**WETLANDS LICENSE NO. 22-0268EX(R1)**  
**DONJON-SMIT, LLC**

*A minor modification (pursuant to COMAR 23.02.04.17.B.(1)) was made to the original license. Changes to original license language are shown with a strikethrough, and revisions shown with bold type.*

Emergency Tidal Wetlands License Request  
Donjon-SMIT, LLC  
Grounding of the MV EVER FORWARD

**MEMO: WETLANDS LICENSE 22-0268(EX) ADDITIONAL DREDGING APPLICATION**

Figure 1: Aft draft and initial dredging depth to 40' (section view left, detailed section view right)

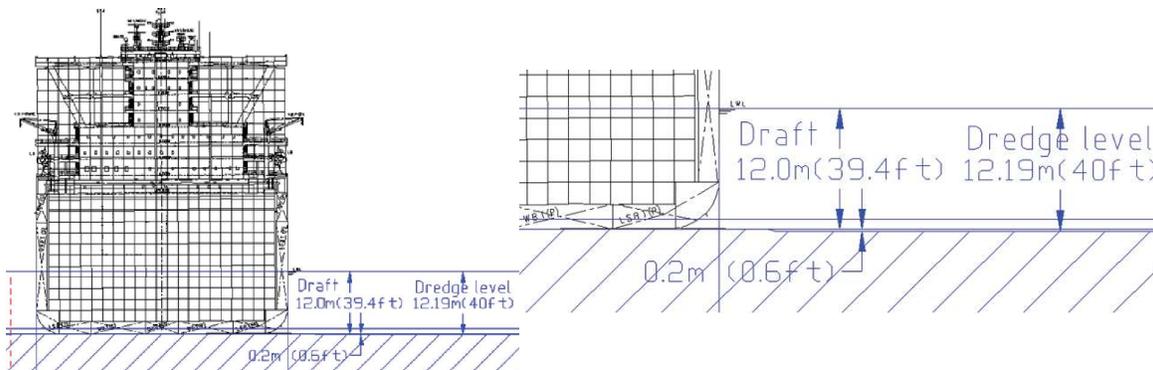
The dredging depth as currently mentioned in the license of 40ft would only create a 'release channel' of 0.6ft deeper than the keel for the soil to flow to, which is not sufficient. Please see **Figure 1** and **Figure 2** below for an illustration of the described current situation.

In addition to the originally requested dredging depth to 40ft, we request a modification of the emergency license allowing us to dredge to 43ft. After reconsideration of our calculations (following the arrival of our internal Dredging Expert), it was concluded that, in order to sufficiently reduce the ground reaction for re-floating purposes, we need to increase the dredging depth.

Figure 3: Aft ship draft and **additional** dredging depth (section view left, detailed section view right)

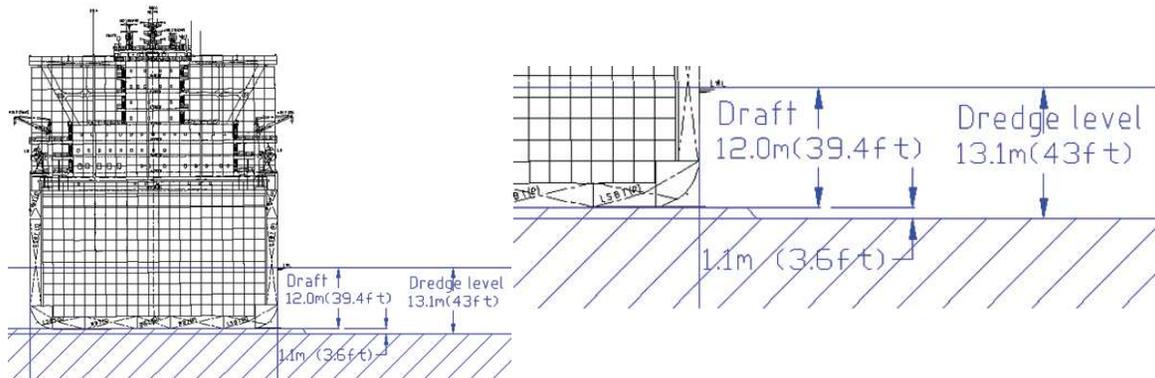
Should the area surrounding the vessel be lowered to the proposed 43', a height difference between the vessel's keel and 'release channel' would be 4ft. This would create significantly more space in the channel for the material underneath the vessel to flow to. Please see **Figure 3** and **Figure 4** below for an illustration of the described desired situation.
